REACTOR COOLANT SYSTEM

3/4.4.6 PRESSURE/TEMPERATURE LIMITS

SUSQUEHANNA - UNIT 1

MINIMUM REACTOR VESSEL METAL TEMPERATURE
VS. REACTOR VESSEL PRESSURE
Figure 3.4.6.1-1

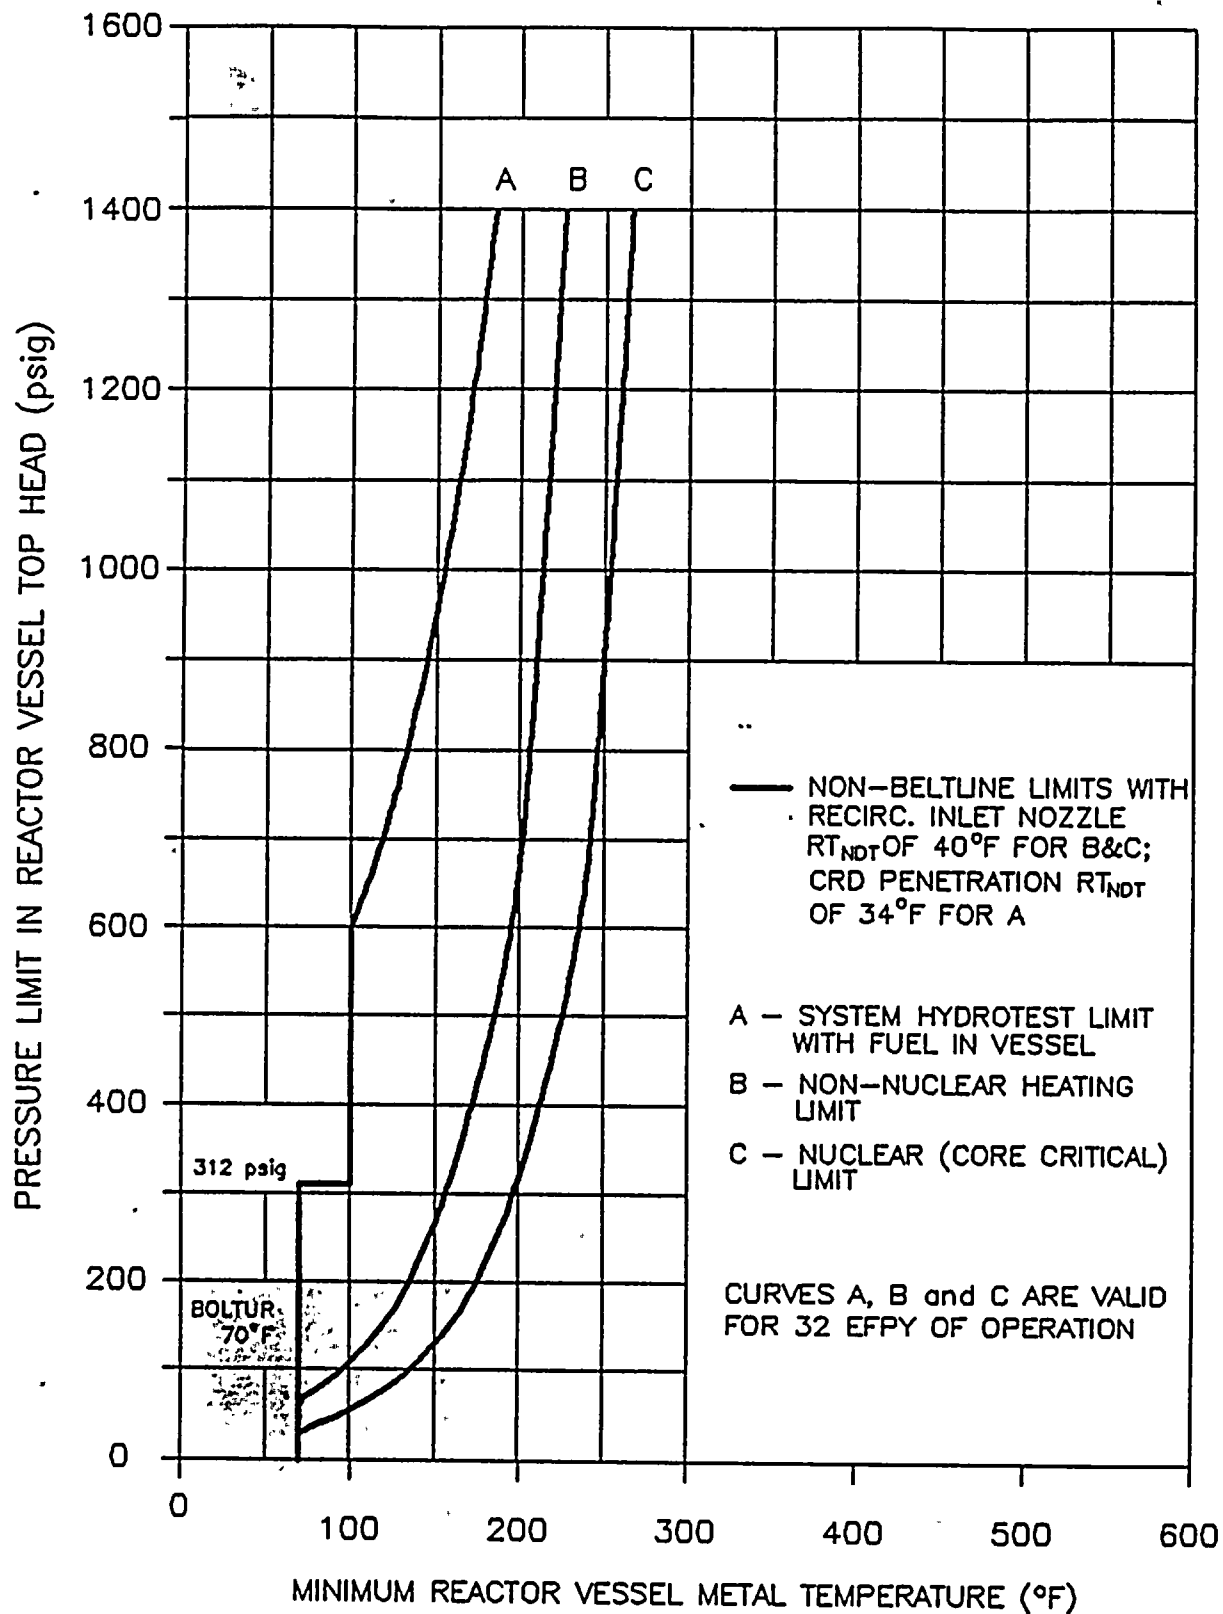
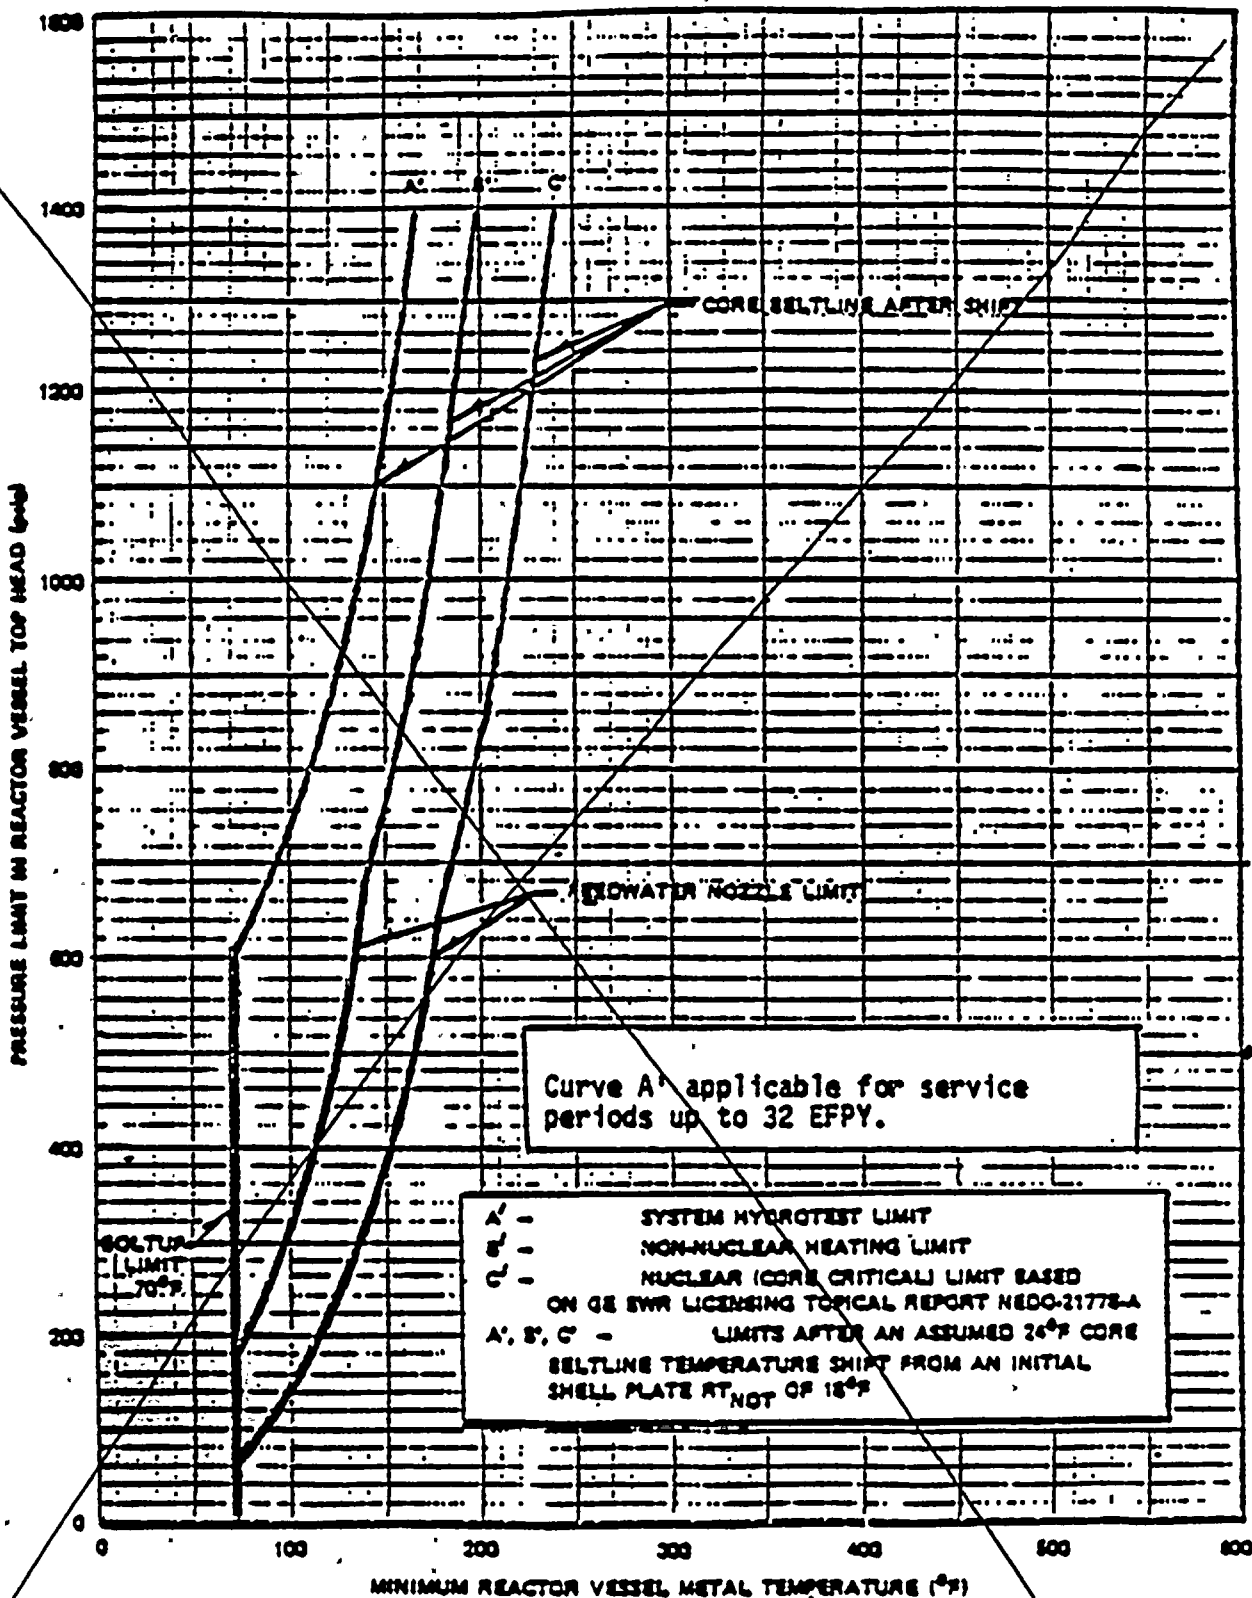
3.4.6.1 The reactor coolant system temperature and pressure shall be limited in accordance with the limit lines shown on FigureX 3.4.6.1-1 and ~~3.4.6.1-2, as applicable~~, for hydrostatic or leak testing, heatup by non-nuclear means, cooldown following a nuclear shutdown and low power PHYSICS TESTS, and operations with a critical core other than low power PHYSICS TESTS, with:

4.4.6.1.3 The reactor vessel material specimens ^{and embrittlement} shall be removed and examined to determine reactor pressure vessel fluence as a function of time and THERMAL POWER as required by 10 CFR 50, Appendix H. ~~in accordance with the schedule in Table 4.4.6.1.3-1.~~ The results of these fluence determinations shall be used to update the curves A and A' of Figure X 3.4.6.1-D ^{and embrittlement} and ~~3.4.6.1-2.~~

*Insert
New Figure*

REACTOR VESSEL PRESSURE VS. MINIMUM VESSEL TEMPERATURE FOR UNIT 1

Bases Figure B 3/4.4.6-1

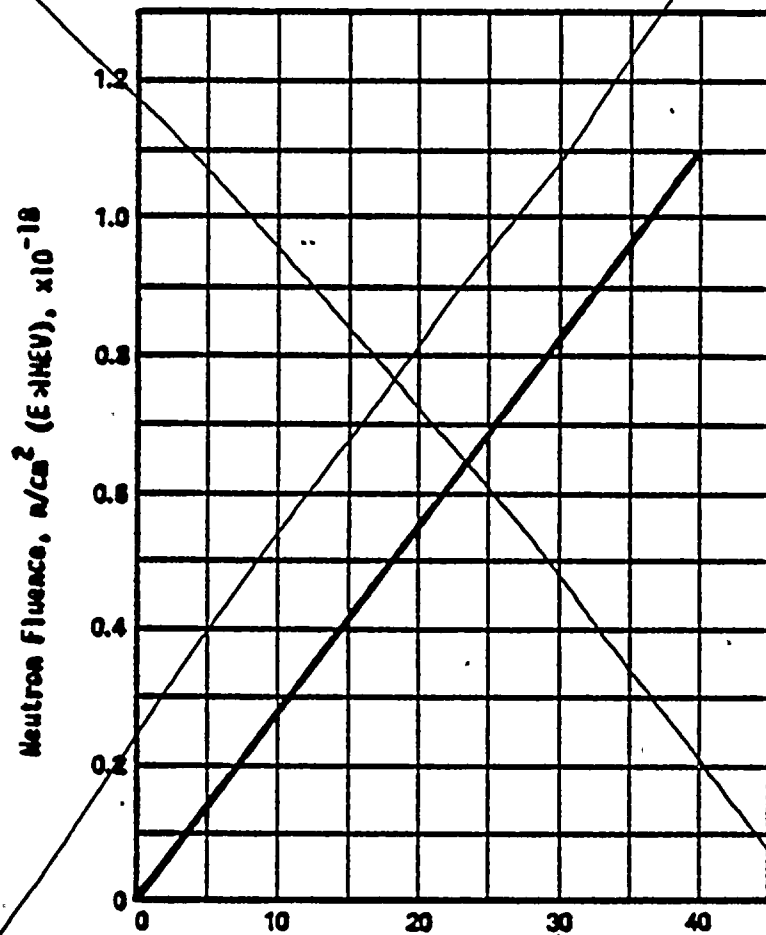
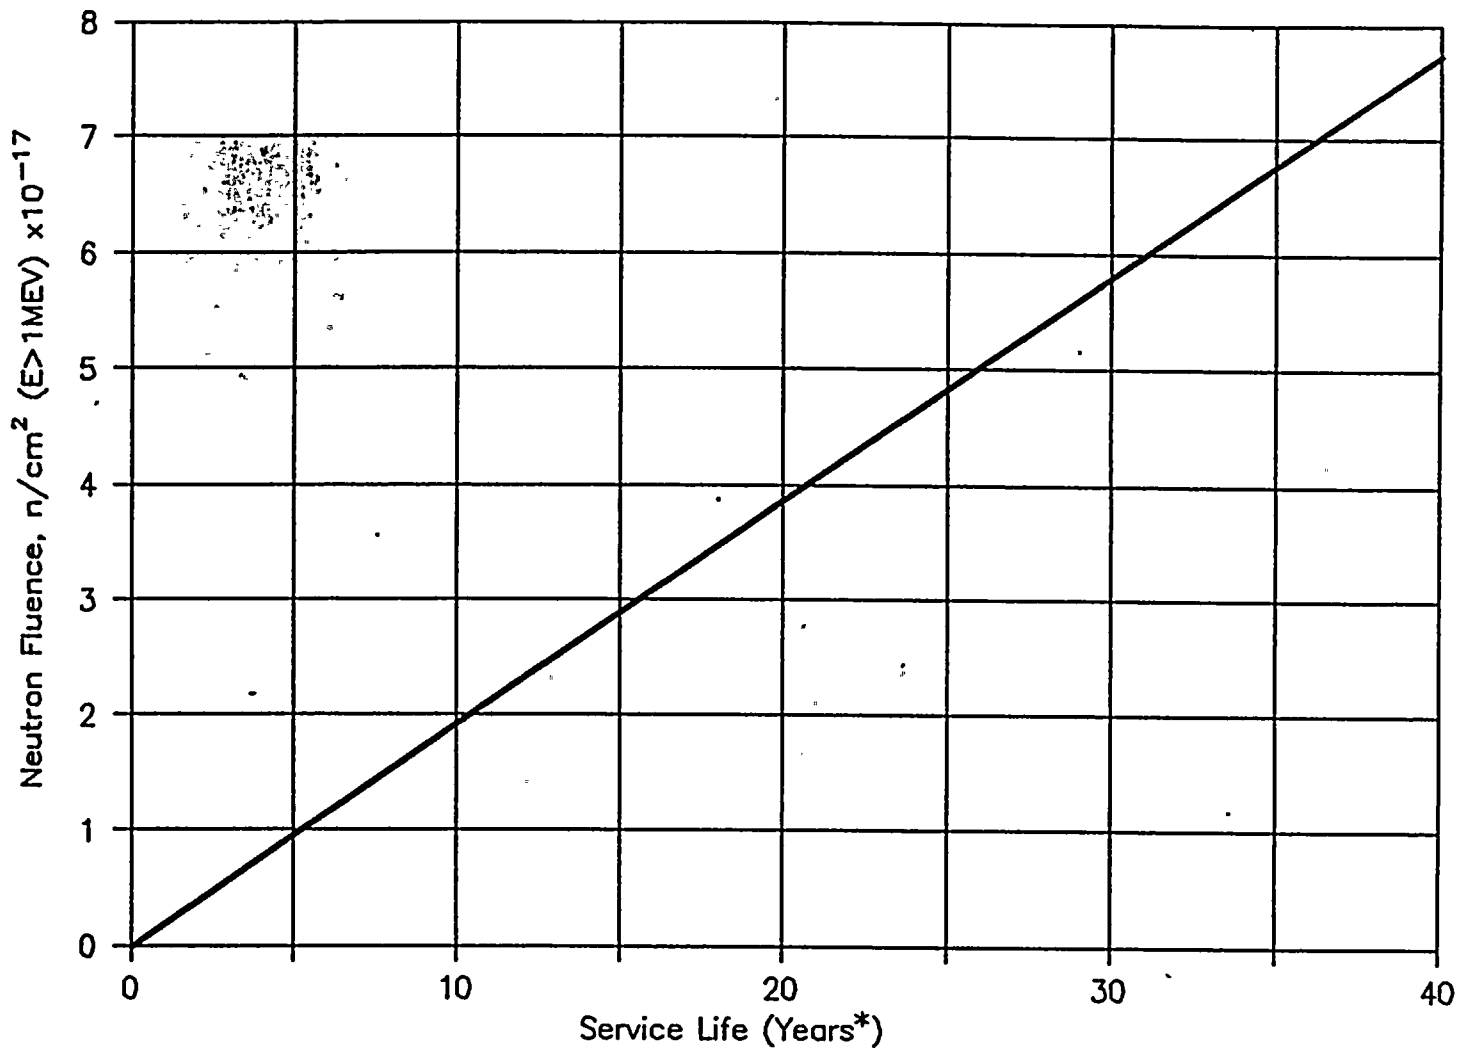
Insert New Figure

Fast Neutron Fluence ($E>1$ Mev) at $\frac{1}{2}T$ As a Function of Service Life*

FIGURE 3.4.6.1-1
 MINIMUM REACTOR VESSEL METAL TEMPERATURE
 VS. REACTOR VESSEL PRESSURE

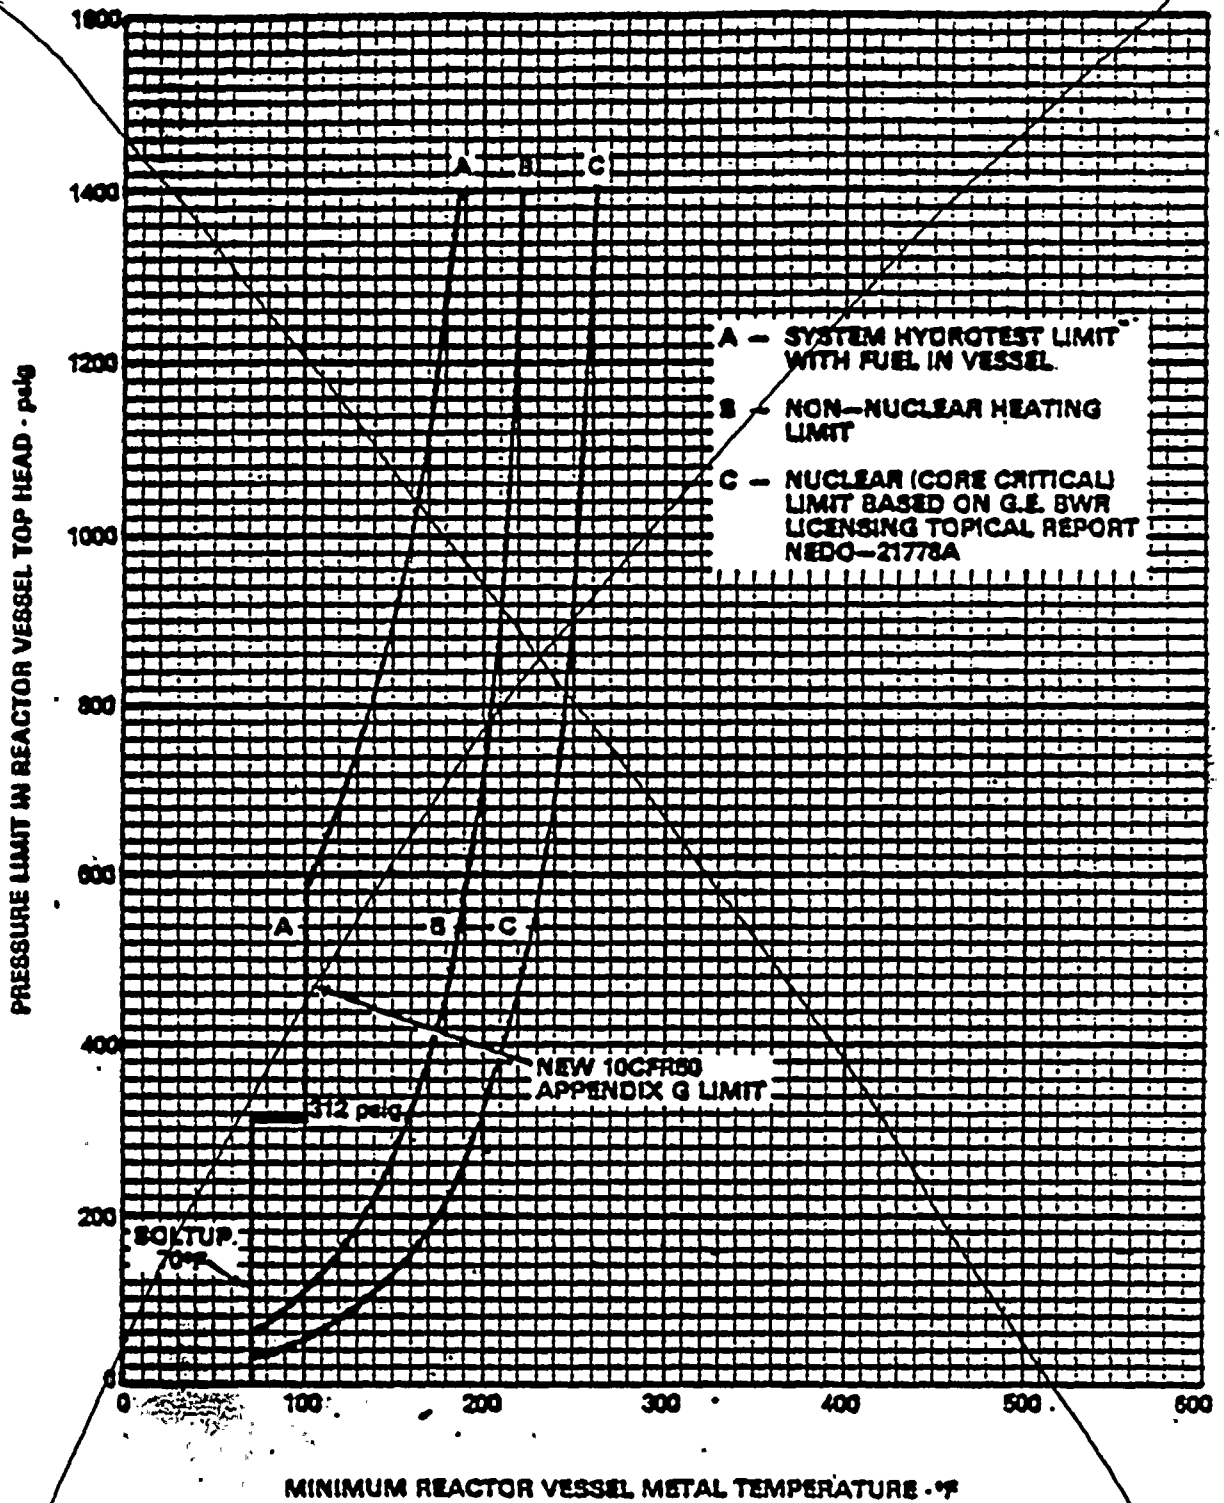
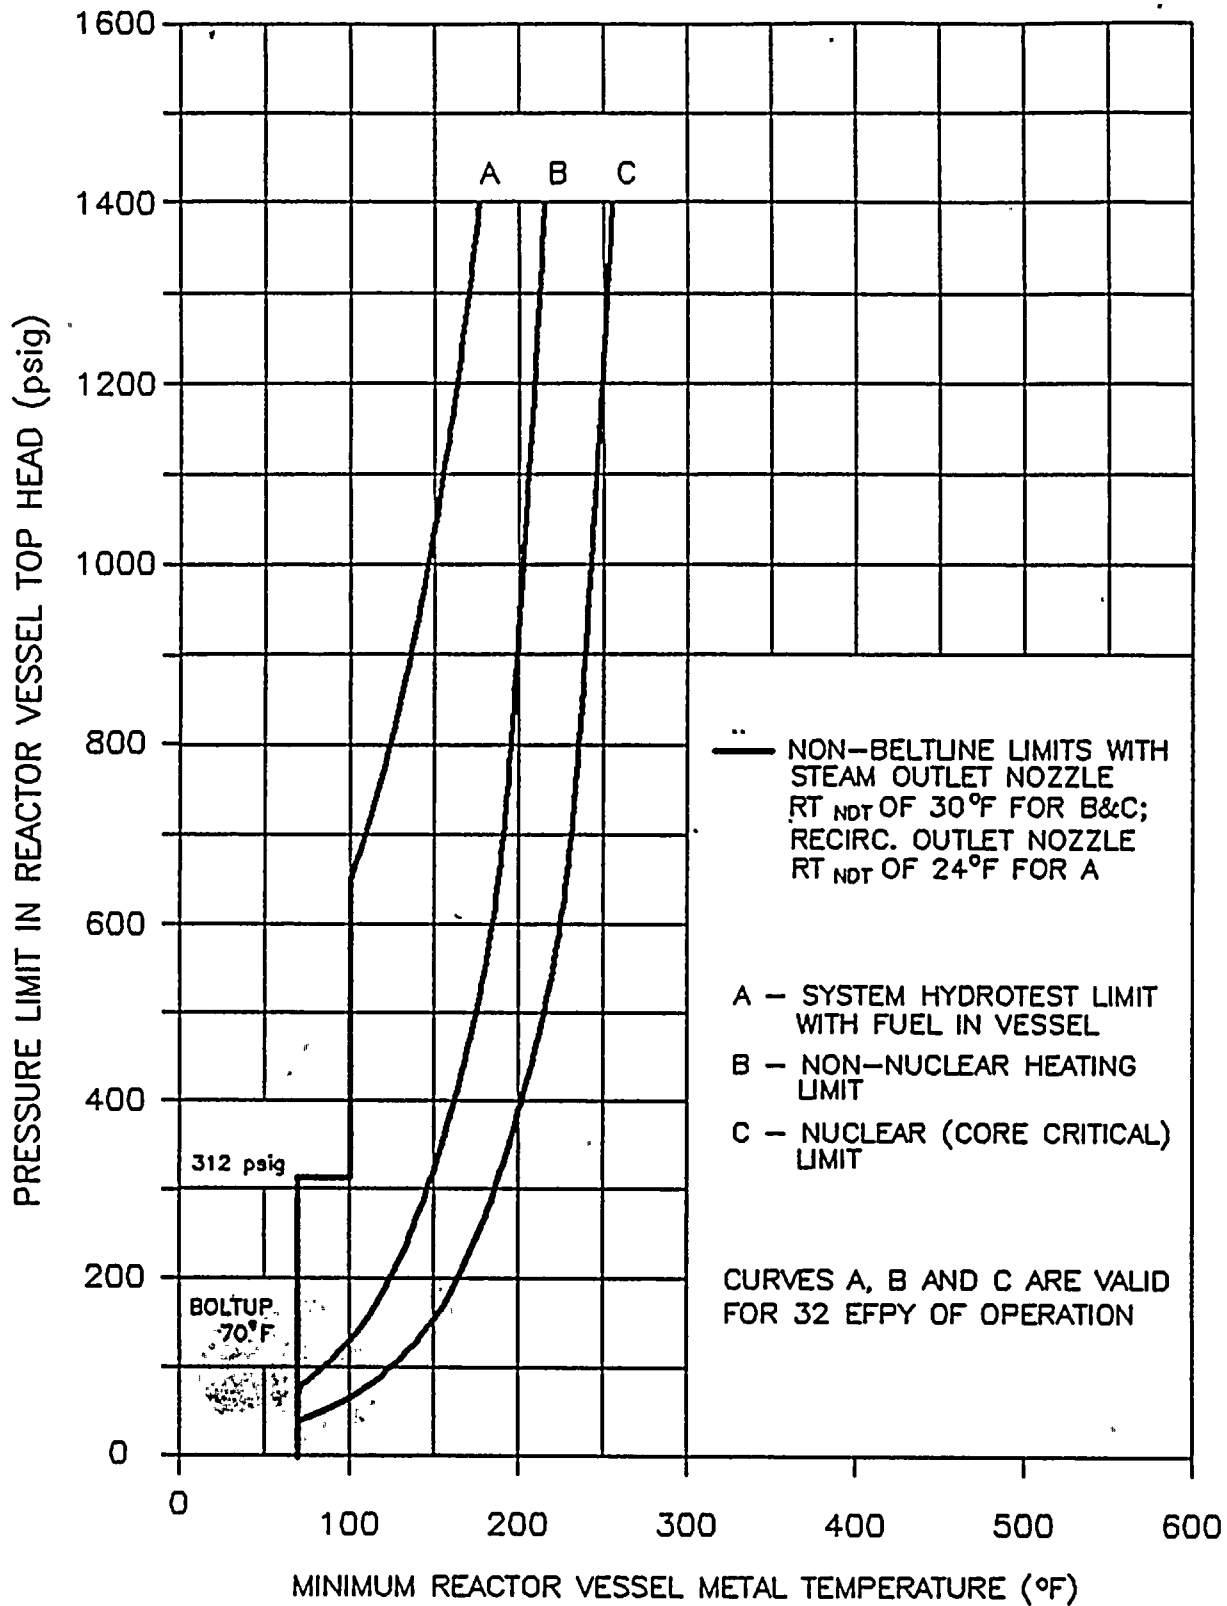
4.4.6.1.3 The reactor vessel material specimens shall be removed and examined to determine reactor pressure vessel fluence as a function of time and THERMAL POWER as required by 10 CFR Part 50, Appendix H. ^{and embrittlement} ~~in accordance with the schedule in Table 4.4.6.1.3-1.~~ The results of these fluence determinations shall be used to update ^{the} ~~curves~~ of Figure 3.4.6.1-1. ^{and embrittlement.}

Insert New Figure

REACTOR VESSEL PRESSURE VS. MINIMUM VESSEL TEMPERATURE FOR UNIT 2
